TECHNICAL MEMORANDUM

To: Aaron Zimmerman
Cc: David Avitabile
From: Maris Fry, P.E.
Daniel VanPelt, P.E., PTOE
Date: March 27, 2019
Subject: 501 Eye Street SW (ZC Case No. 17-21)
Response to DDOT Staff Report

This memorandum is a response to the DDOT Staff report dated March 18, 2019, regarding the 501 Eye Street SW (The Bard) project (ZC Case No. 17-21). In order to mitigate the impacts of the development, DDOT has requested an increase in the strength of the TDM plan. The Applicant has agreed to strengthen the TDM plan as outlined in this memorandum. Additionally, DDOT has requested additional clarification on site design elements and Transportation Management Plan elements that have been revised since the completion of the Comprehensive Transportation Review (CTR) that was submitted on December 3, 2018.

Figure 2: Proposed Curbside Management

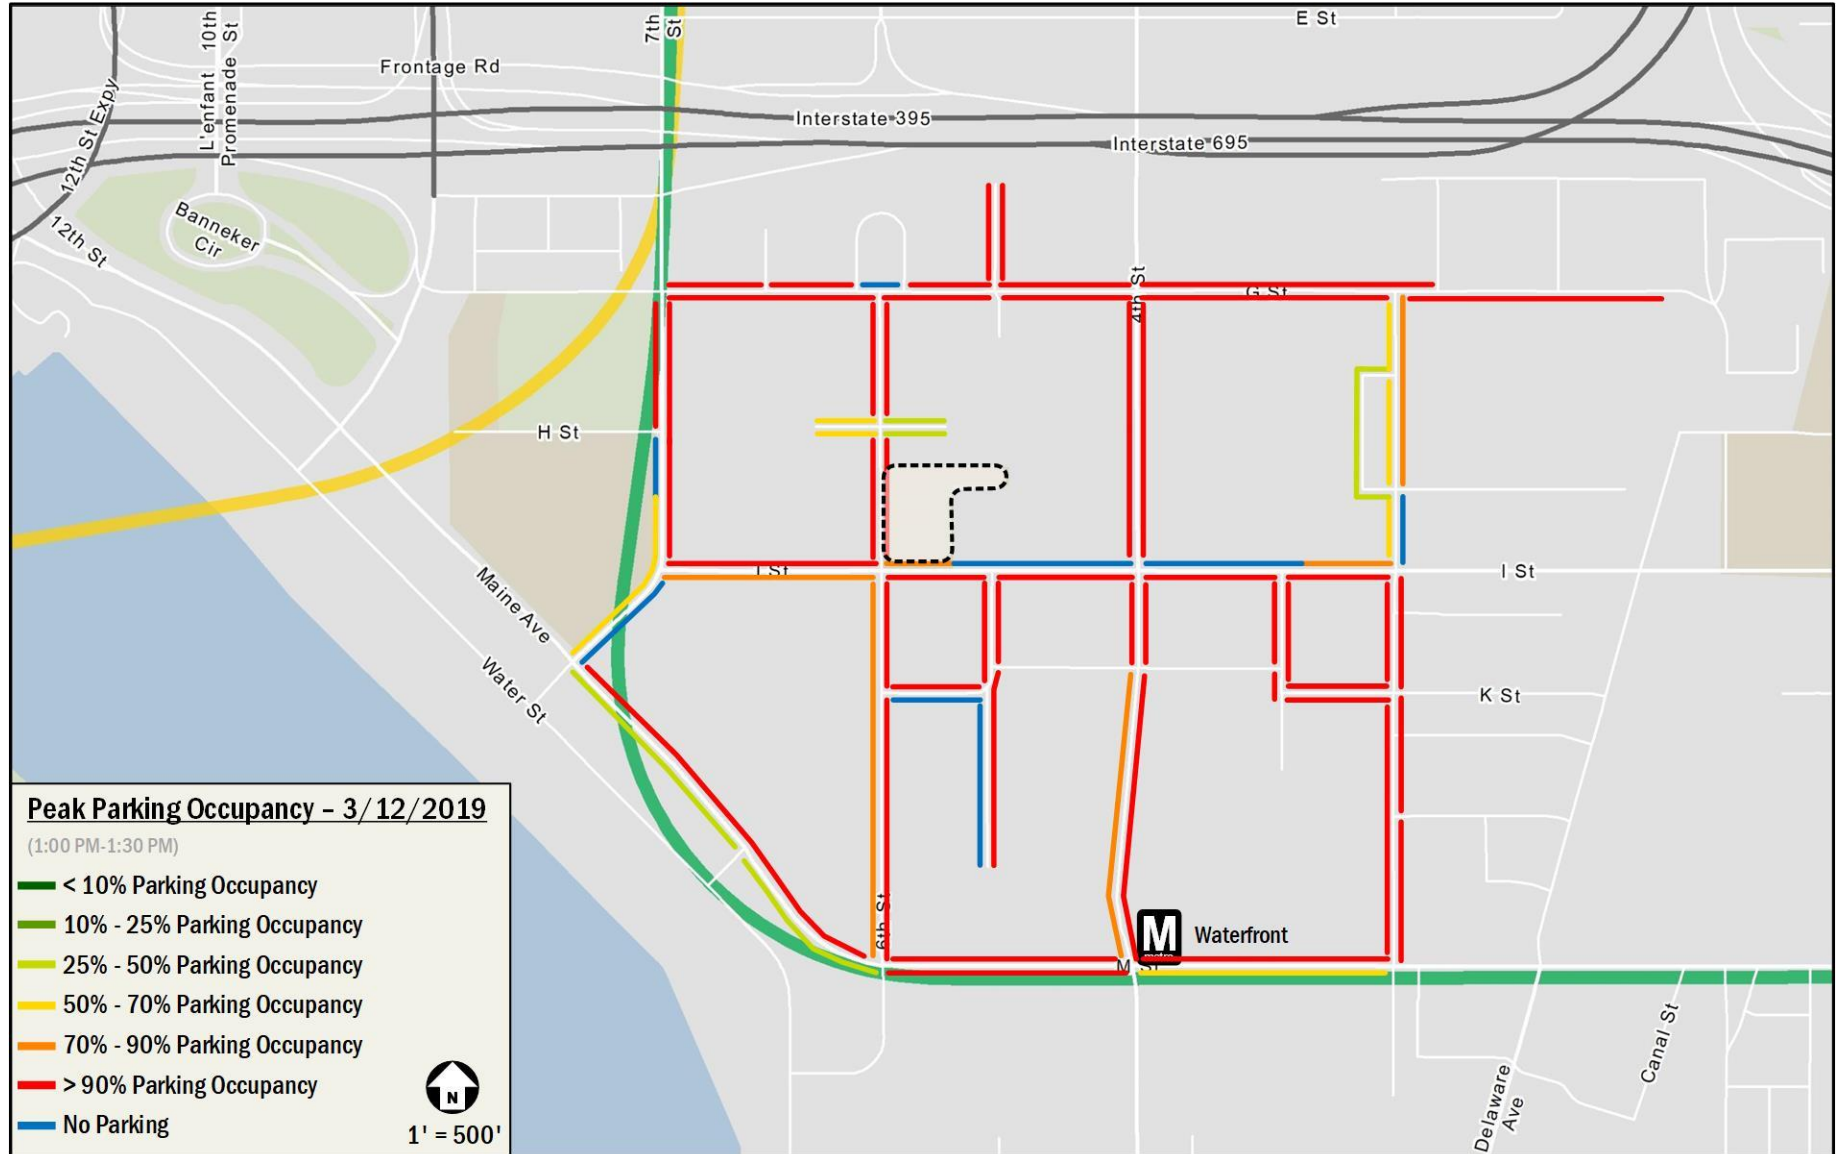
DDOT Comment: The Pick-up/Drop-off Operations Plan should be revised to reflect the latest conversations between the Applicant, the ANC, Amidon-Bowen Elementary School, [UNSW], and DDOT.

As shown on Figure 2, a 60-foot entrance zone is proposed at the southeast corner of the site. Approximately 20 feet of this entrance zone is obtained through the closure of a curb cut along I Street and approximately 40 feet is taken from the existing ROP curbside space. This results in a loss of approximately two (2) ROP spaces.

East of the entrance zone, it is proposed that curbside currently signed as “No Parking 7/8 AM-5:30 PM School Days” be converted to “No Parking M-F 7 AM to 5:30 PM”. This adjustment results in curbside space for summer pick-up/drop-off needs for the proposed development, as well as the adjacent Amidon-Bowen Elementary School which also has summer activities. This proposed change still allows for unrestricted parking to be available to the surrounding community in the evenings and weekends.

Response: The Pick-up/Drop-off Operations plan has been revised as follows:

The proposed curbside management plan allows for a continuous curbside pick-up/drop-off space of approximately 170 feet (or approximately 9 car lengths) for STC’s summer camps. Based on information provided by STC, this amount of queuing space is expected to be sufficient for pick-up/drop-off activity.

GROUND LEVEL PLAN

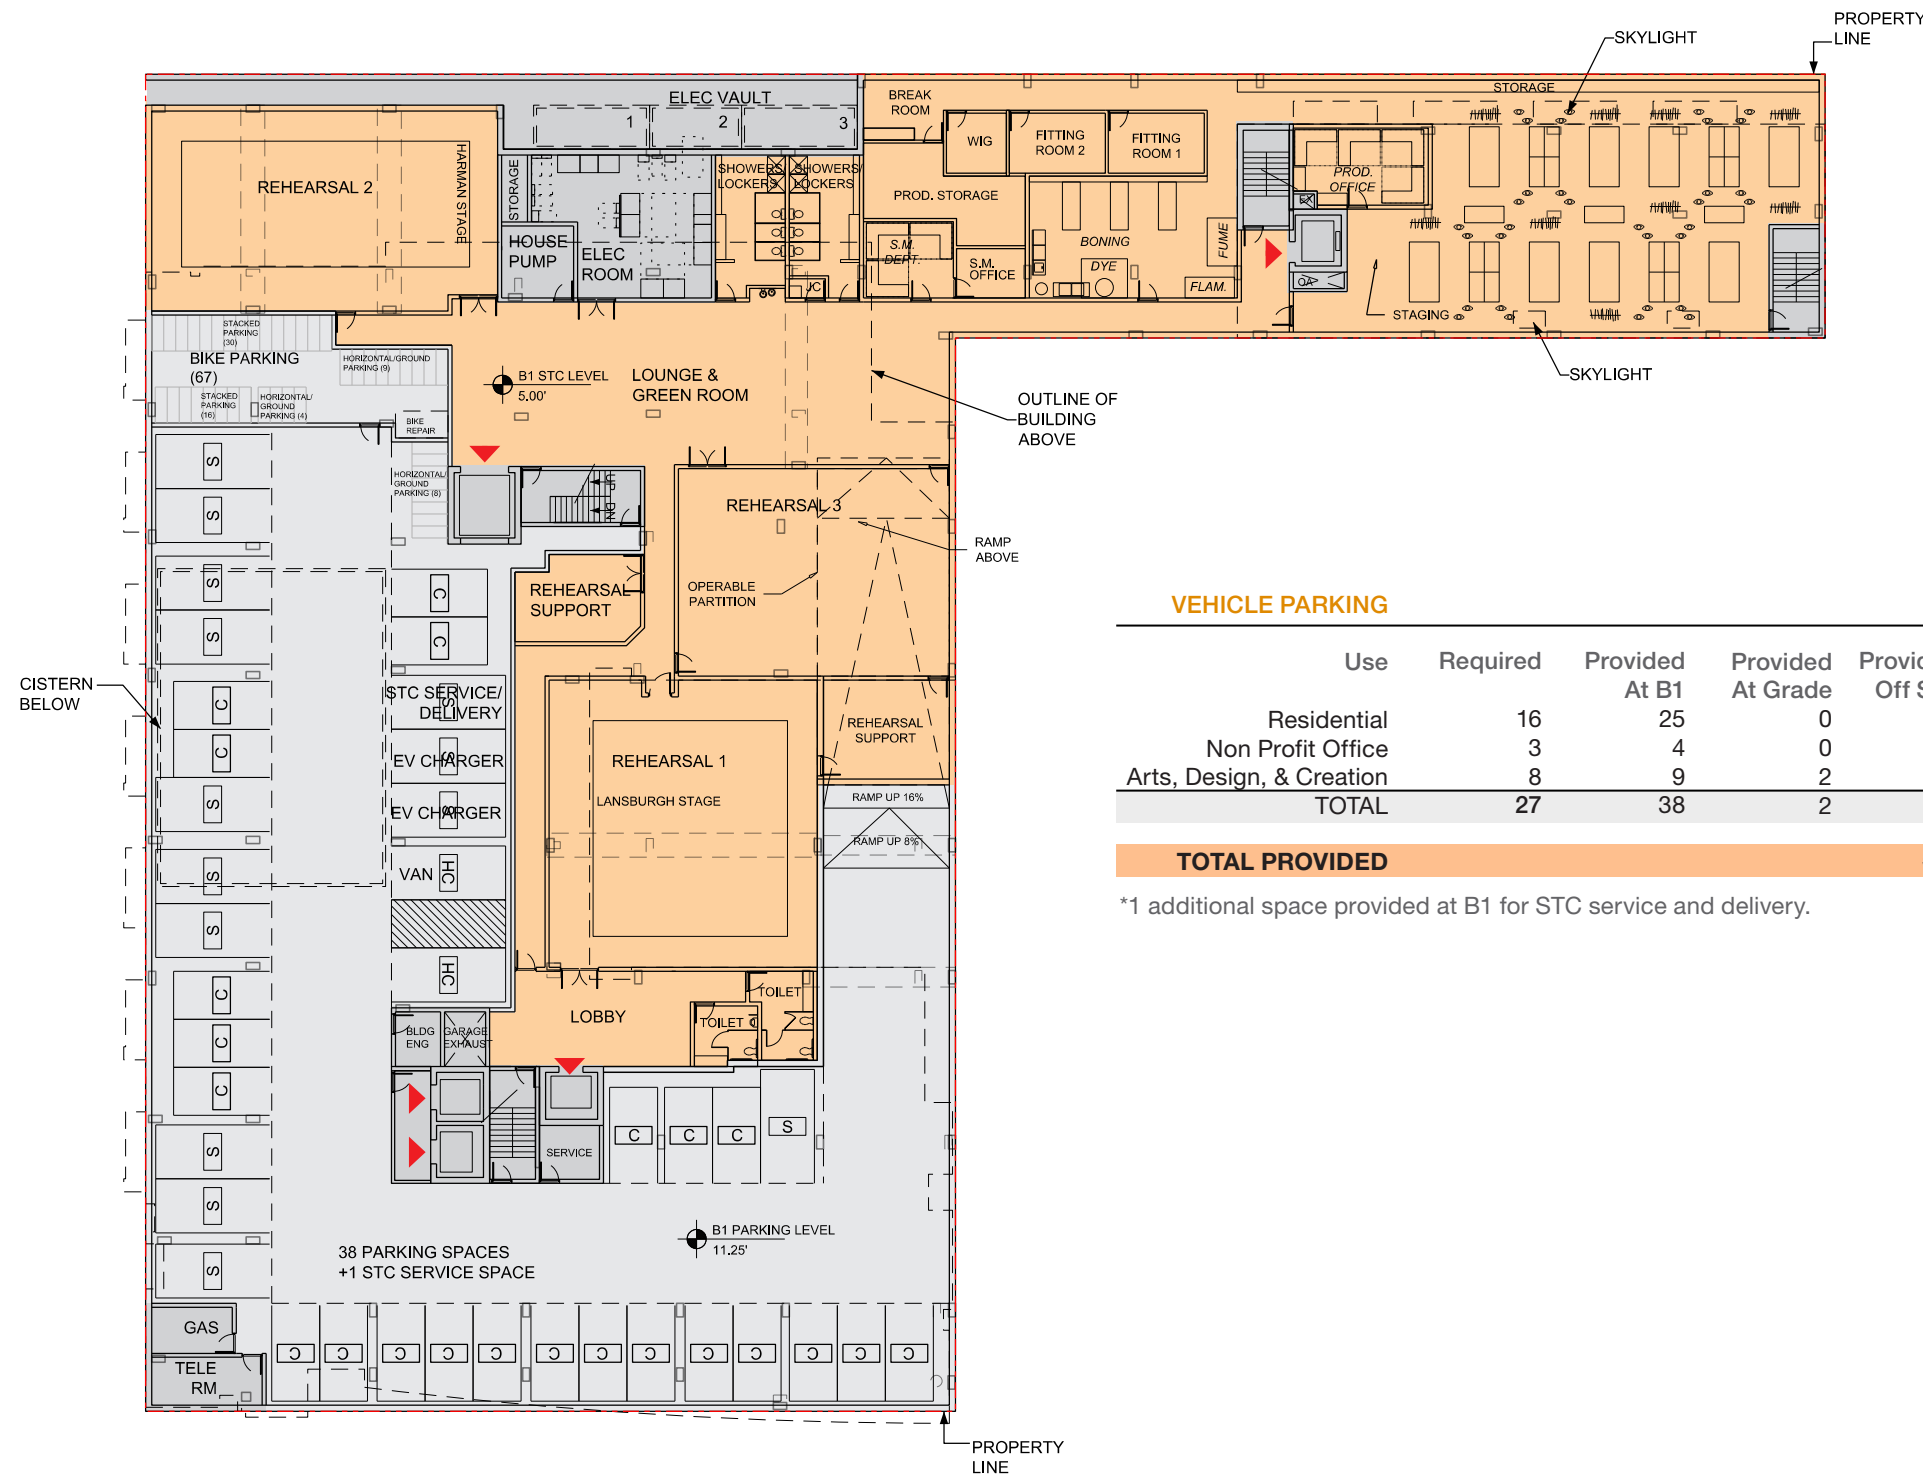
DDOT Comment: It is not clear if the ZR16-required loading platform is included. It should be shown on the plans.

Response: The proposed loading platform is shown on page 3.3 of the supplemental pre-hearing submission (outlined to the left of the 30-foot loading berth). For reference, this exhibit has been included as an attachment to this memorandum.
